Re: Revised Colusa Subbasin Groundwater Sustainability Plan

AquAlliance, the California Sportfishing Protection Alliance, and the California Water Impact Network (hereinafter AquAlliance) submit the following comments and questions on the Revised Colusa Subbasin Groundwater Sustainability Plan (“Revised GSP” or “Plan”) to the Colusa Groundwater Authority and the Glenn Groundwater Authority GSAs (“GSAs”).

Domestic Well Impact Relative To Initial and Proposed MTs for RMS Well 14N03W14Q003M (Focus Area)
 (Total Number of Domestic Wells in Area = 12)

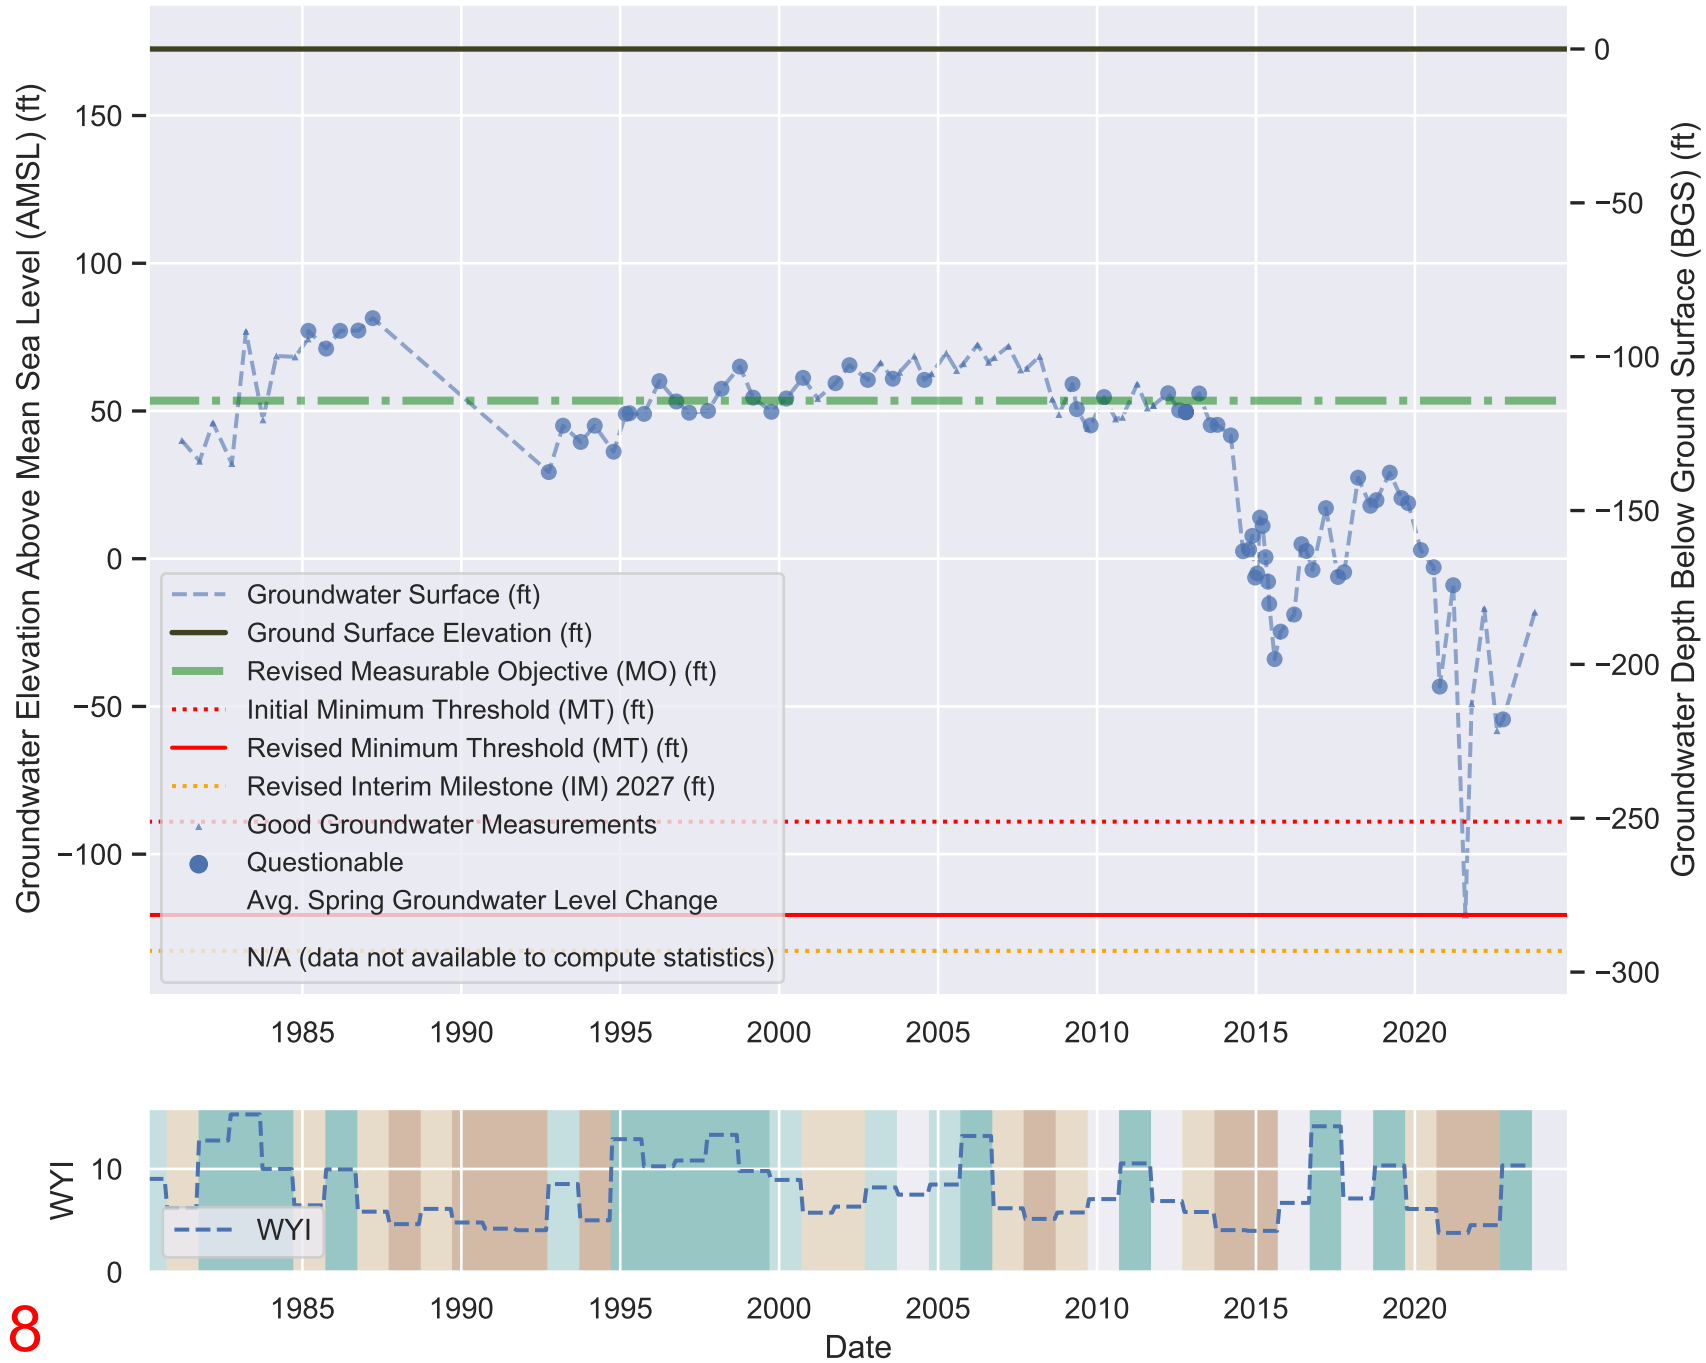
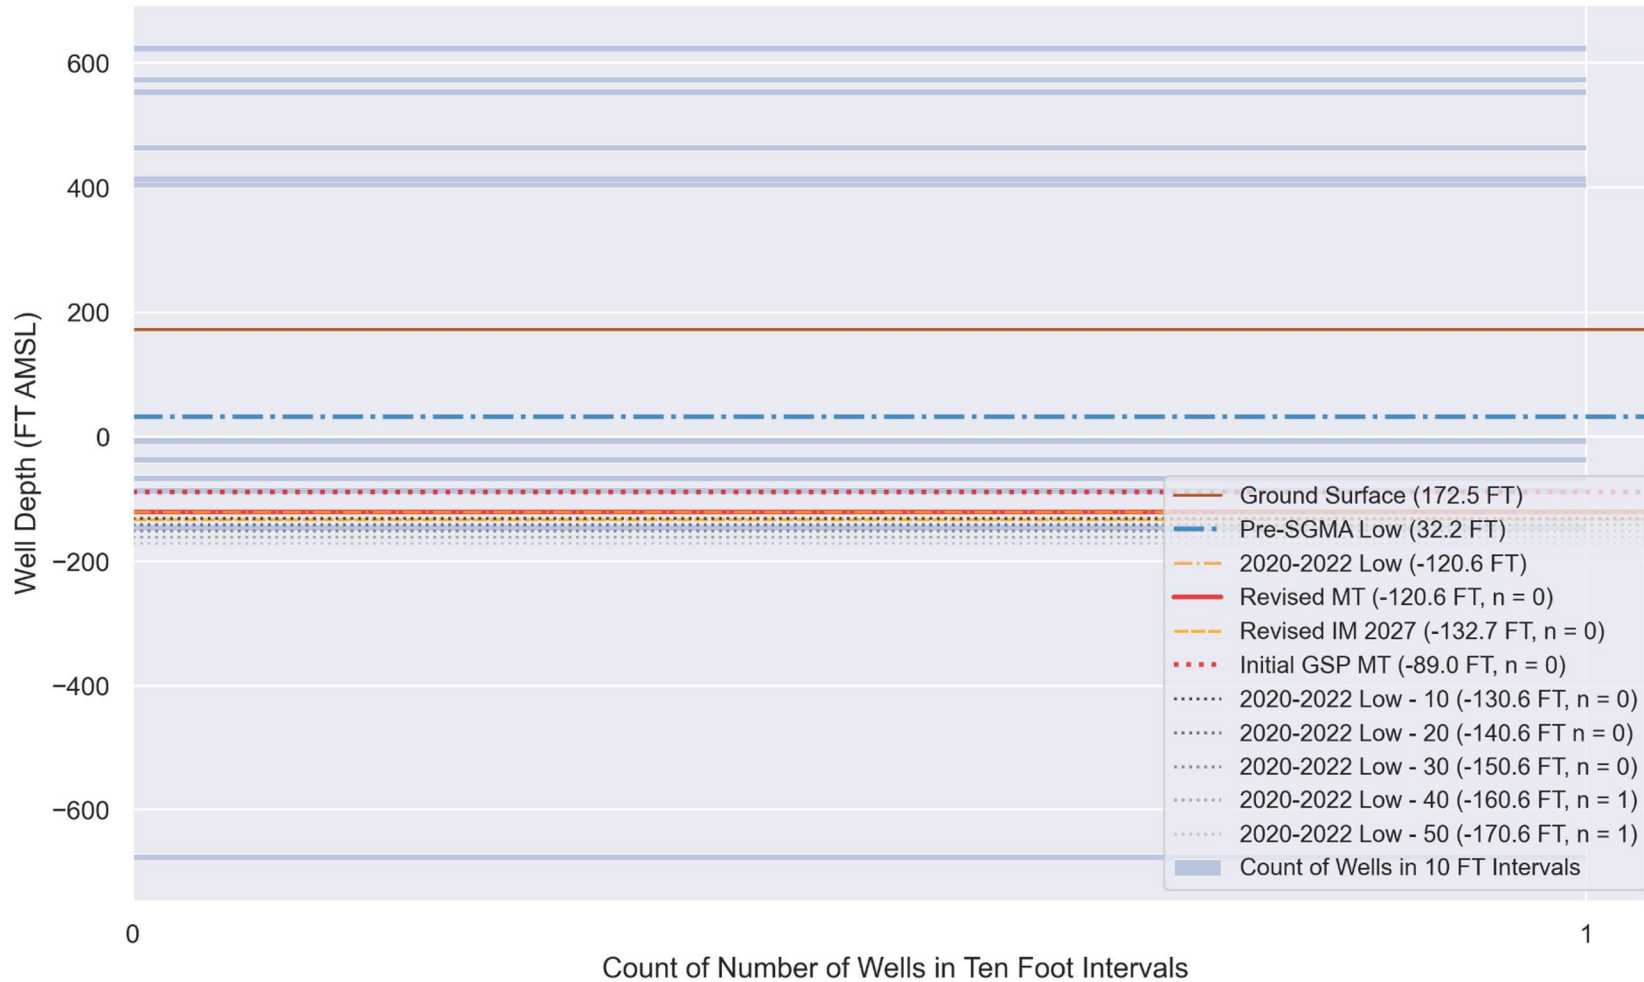
The Revised GSP values for the Focus RMS well MT were generally set at an elevation higher than the original MTs, but the MTs in two of the wells were set slightly lower: wells 14N03W14Q003M and 22N03W24E002M. The MT in the 14N03W14Q003M well has gone from an original elevation of -89 feet to a revised elevation of -120.6 feet (31.6 feet lower; see attached hydrograph) while the MO has risen from an elevation of -13 feet to +53.5 feet. The MT in the 22N03W24E002M well has gone from an original elevation of +122 feet to a revised

COLUSA Subbasin - State Well Number (SWN): 22N03W24E002M (Focus RMS Well)

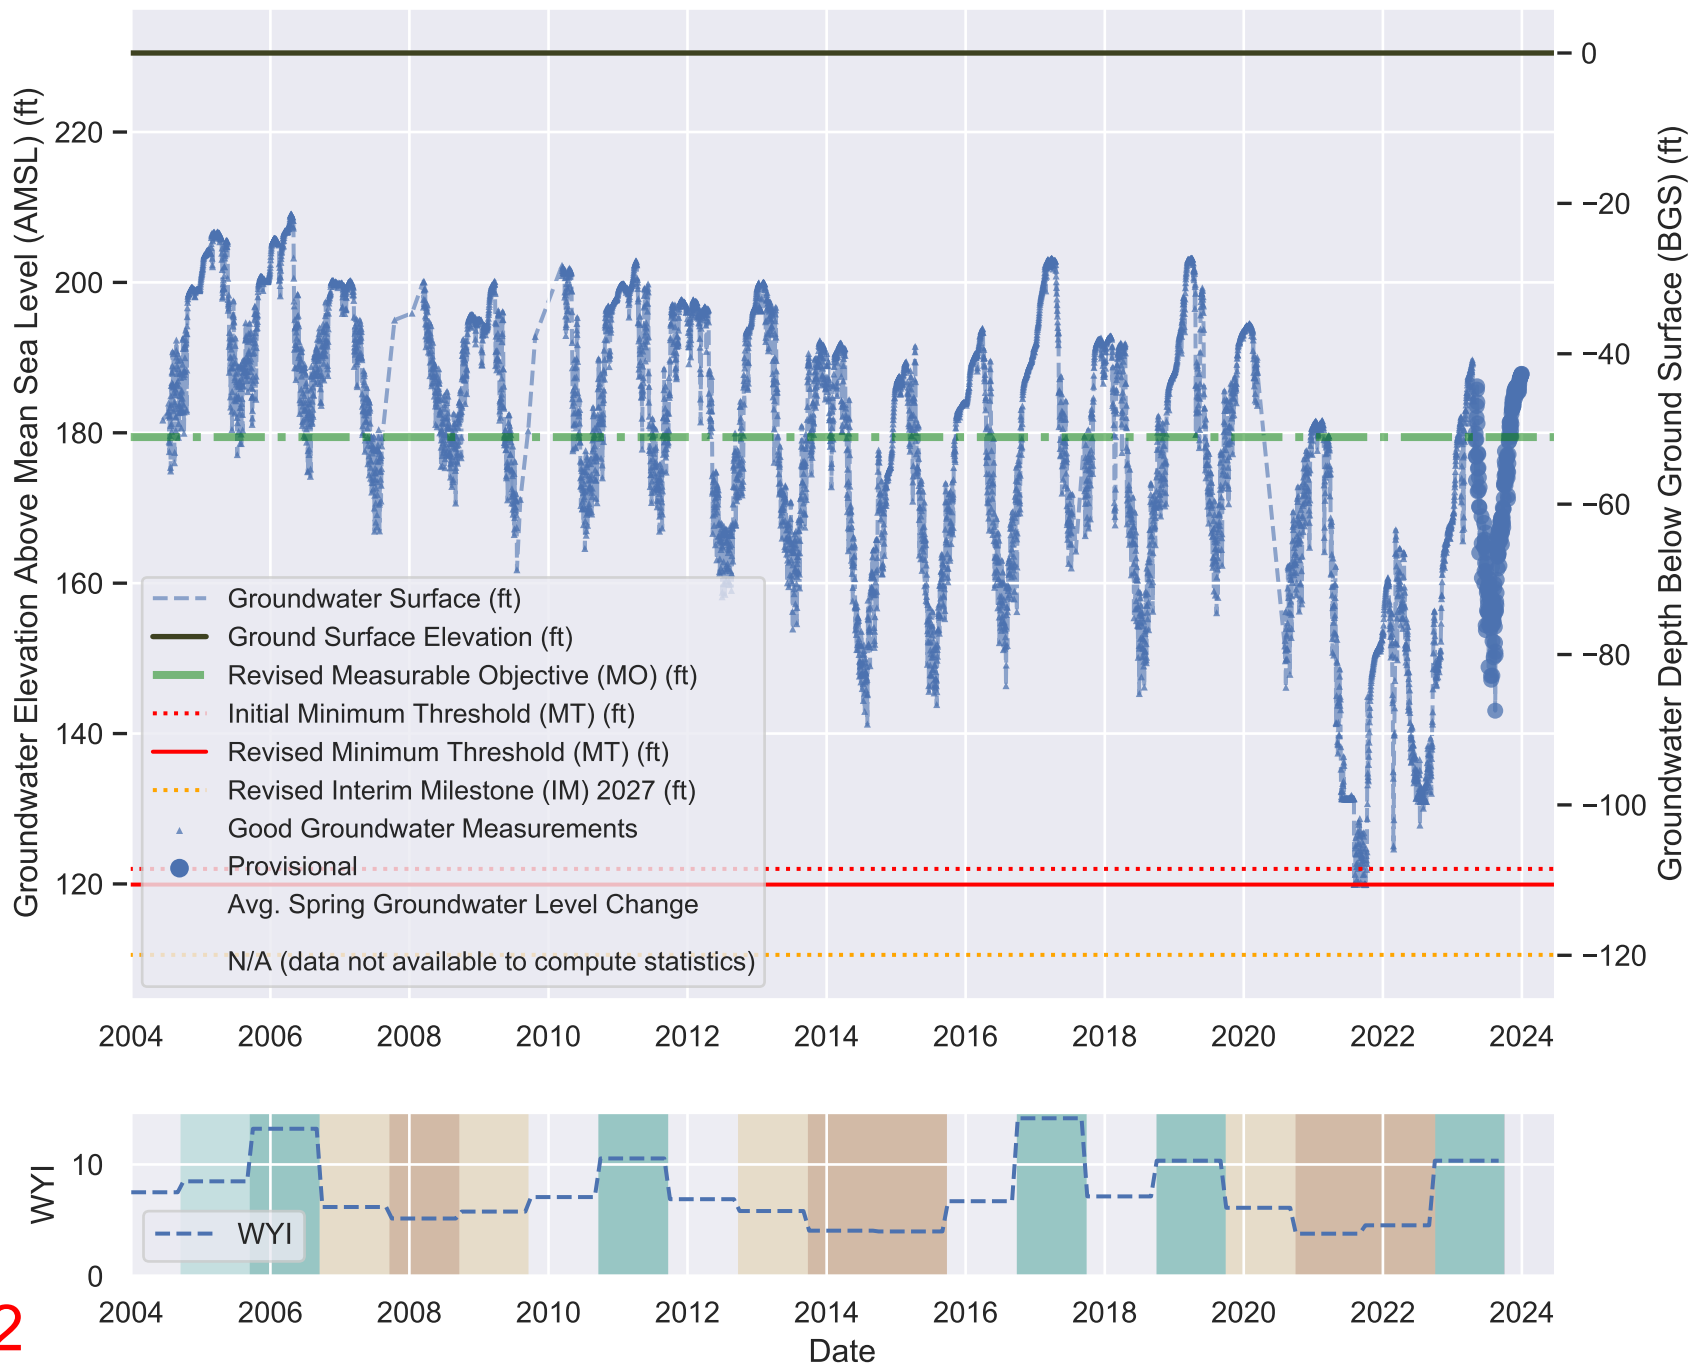
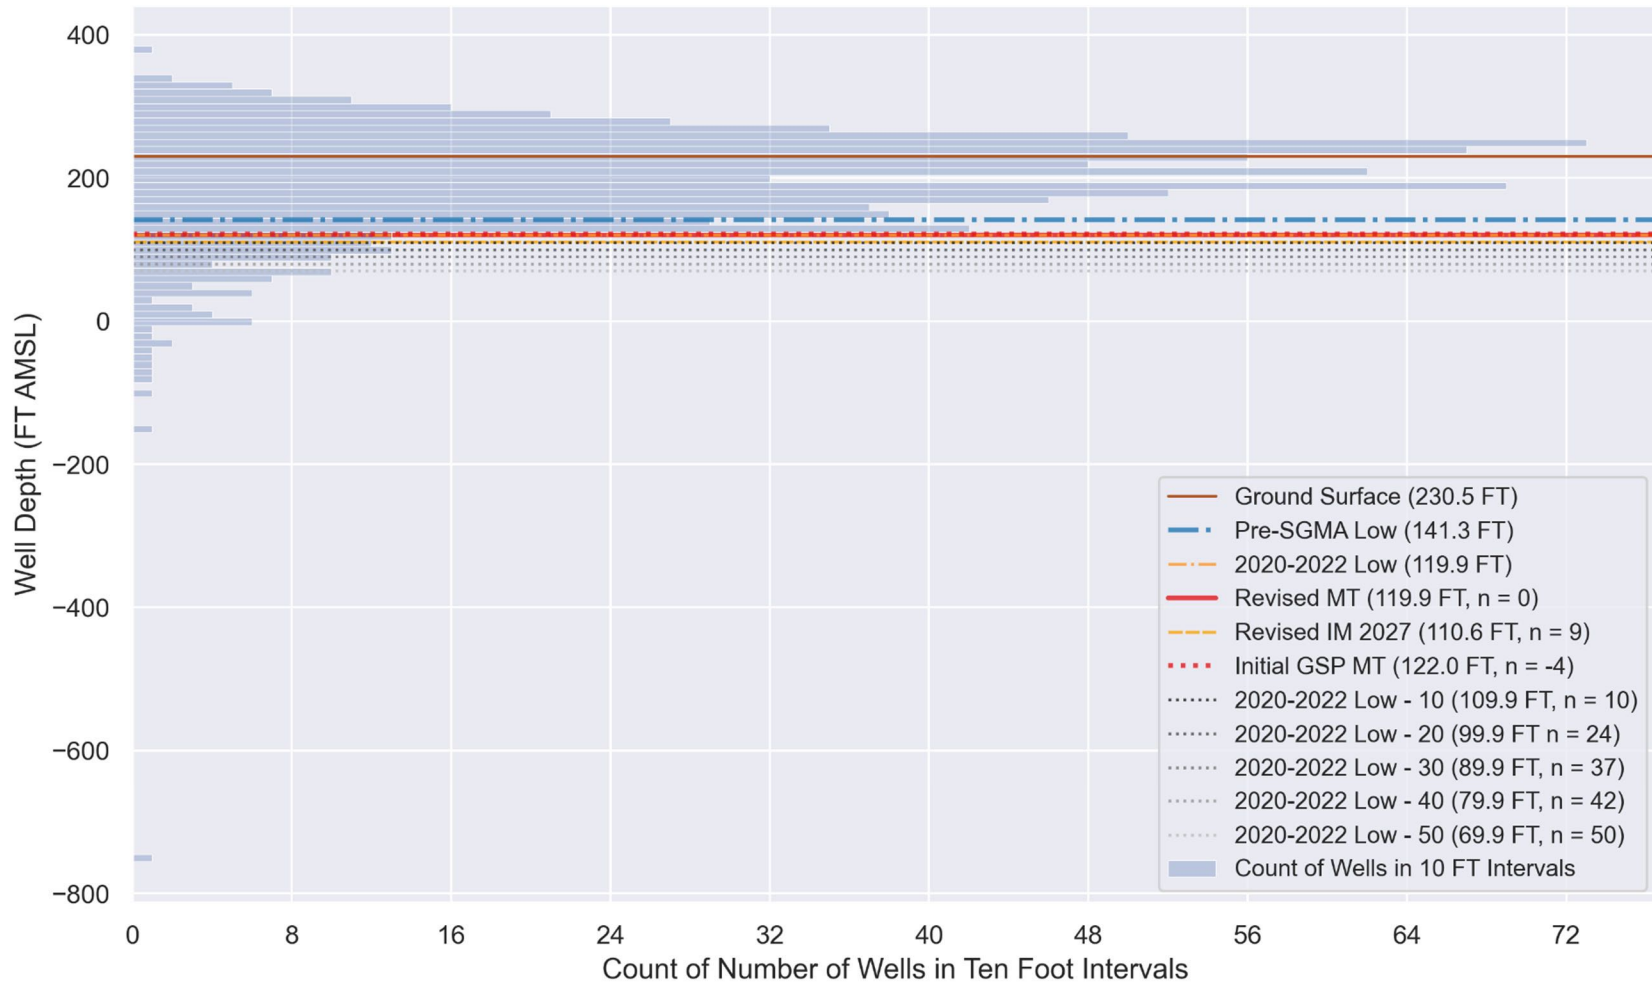
elevation of +119.9 feet (2.1 feet lower; see attached hydrograph) while the MO has risen from an elevation of +176 feet to +179.4 feet. The apparent reason for lowering the MT is that the 2020-2022 groundwater level was lower than the original MT elevation.

Another change in the sustainability threshold elevation for the Focus RMS wells is the change in the 2027 Interim Milestone (IM) elevation. In the original GSP, the 2027 IM elevations for all the RMS wells were set equal to the MO elevations. For the Revised GSP, that condition still applies only to the Non-Focused RMS wells (see Table 2 in Appendix 5E, pp. 7 and 8, pdf pp. 9 and 10). For the revised Focus RMS well, the IM elevations are not set at the recent low (MT) minus a five-year continued decline in water surface elevation at the average annual rate of change in the water surface elevation. For example, the IM for Focus RMS well 22N03W24E002M has been lowered from the original elevation of +176 feet, to the revised IM elevation of 110.6 feet (65.4 feet lower; see attached hydrograph).
